UNITED STATES PATENT AND TRADEMARK OFFICE

APPLICATION NO.	FILING DATE	FIRST NAMED INVENTOR	ATTORNEY DOCKET NO.	CONFIRMATION NO.
10/567,247	02/20/2007	Roger Arnold Stromsoe	ADMS-0011	4587
23377 7590 04/28/2008 WOODCOCK WASHBURN LLP CIRA CENTRE, 12TH FLOOR 2929 ARCH STREET PHILADELPHIA, PA 19104-2891				
EXAMINER SCHILLER, ALINA				
ART UNIT 3671		PAPER NUMBER		
MAIL DATE 04/28/2008		DELIVERY MODE PAPER

Office Action Summary

DETAILED ACTION

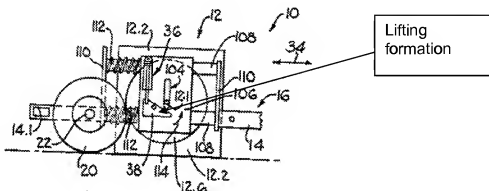
Jeffrey teaches that it is well known in the art to have a lifting arm (38, Fig. 17) with a depending lifting formation (as seen in the modified picture below taken from Fig. 17) and a piston/cylinder mechanism (36) which is extensible to pivot the lifting arm in the direction of arrow (114) thereby to engage and raise the roller axle (12.1), to lift the roller from the ground (col. 19, lines 14-16), having a connection point for lifting the roller higher (as seen in Fig. 17) than that of Berrange. It would have been obvious to one having ordinary skill in the art at the time the invention was made to modify the apparatus of Berrange to have the connection point for the lifting arrangement higher, as taught by Jeffrey, so that the lifting arm is located above the drag link, as an equivalent structure for a lifting arrangement well known in the art. Further, this combination would result in the piston mechanism operable to displace the lifting arm between a first position, in which the lifting formation is spaced from the axle assembly to be engaged thereby, and a second position, in which the lifting formation is engaged with the axle assembly and the non-round roller is thereby raised with respect to
